## STAFF REPORT

### **Petition 12-11**

### **Petition 13-11**

**Petition 12-11** Toll Brothers applicant, Balf Company property owner, requests approval for a 71 lot single-family home subdivision on 73.7 acre property zoned for R-20 (20,000 square foot) development.

# Areas of Greater than 15% Slope

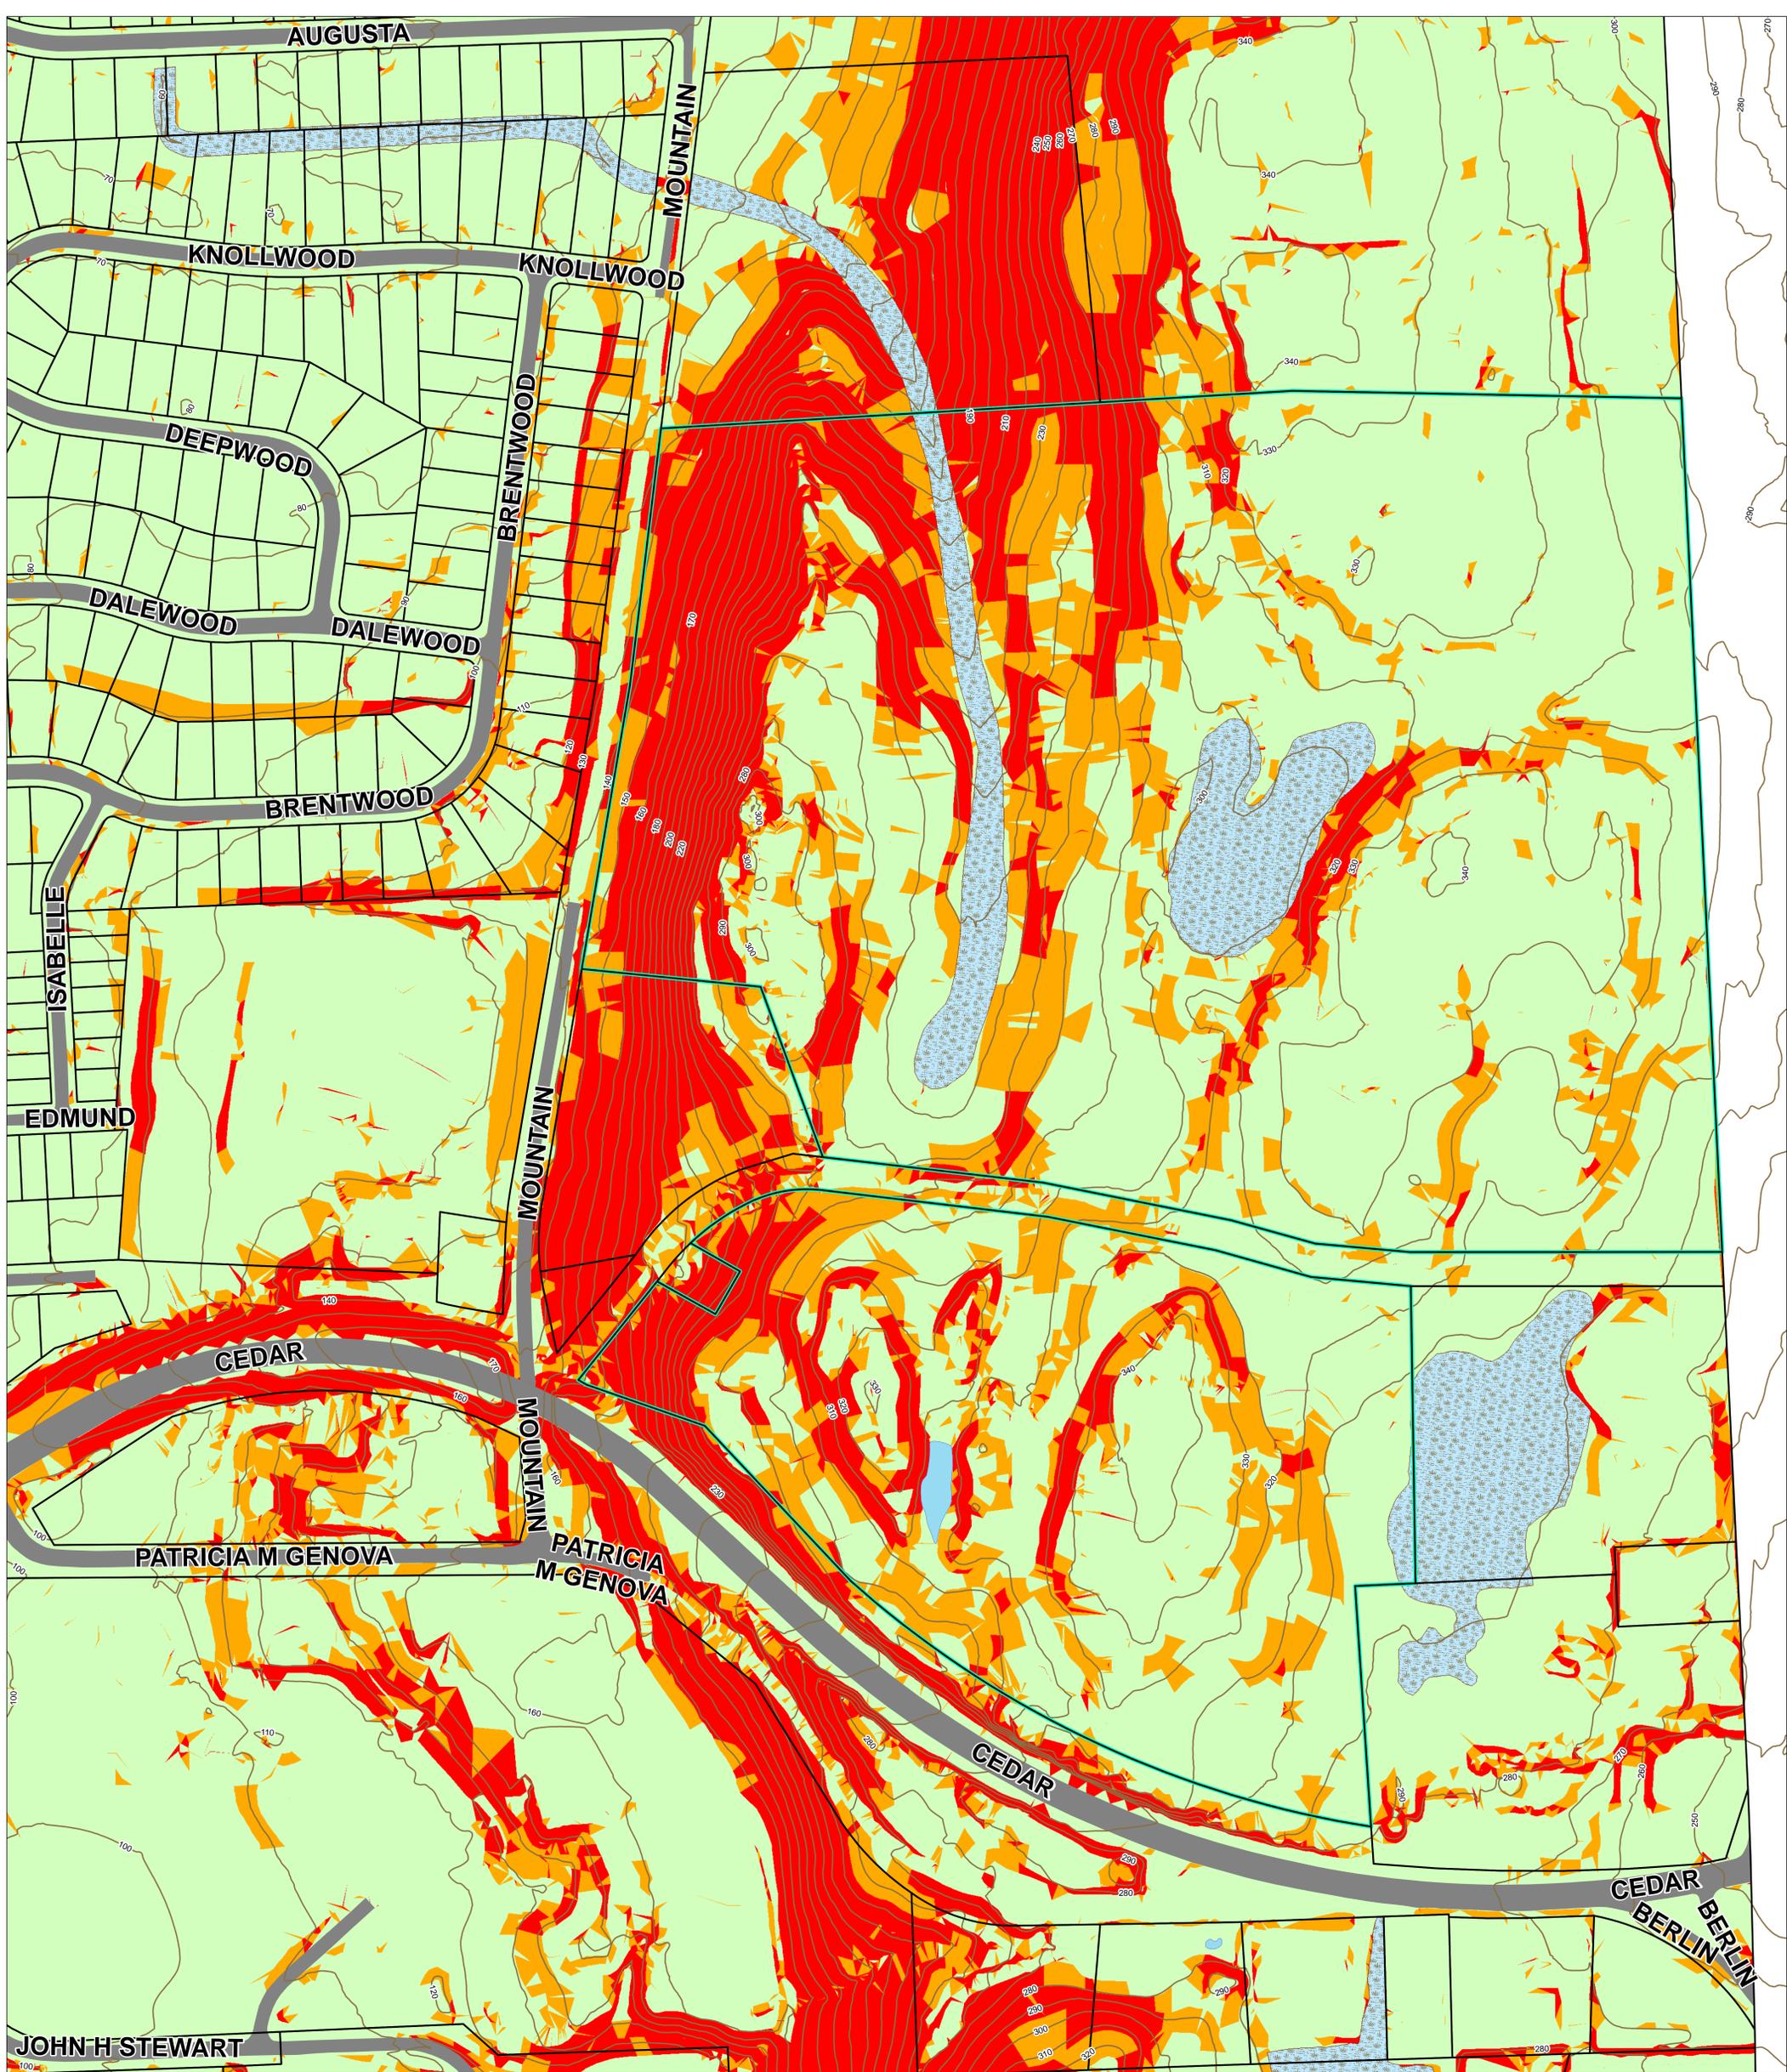
Town Planner estimates approximately 28 acres, (38%) of 73 acre parcel, have slopes in excess of 15%. The steep slope areas are concentrated along the westerly ridge, in the north central section of the parcel adjacent to Cedar Crest Hospital and a narrow crescent shape ridge at elevation 330' – 340' in the central part of property. (See attached map)
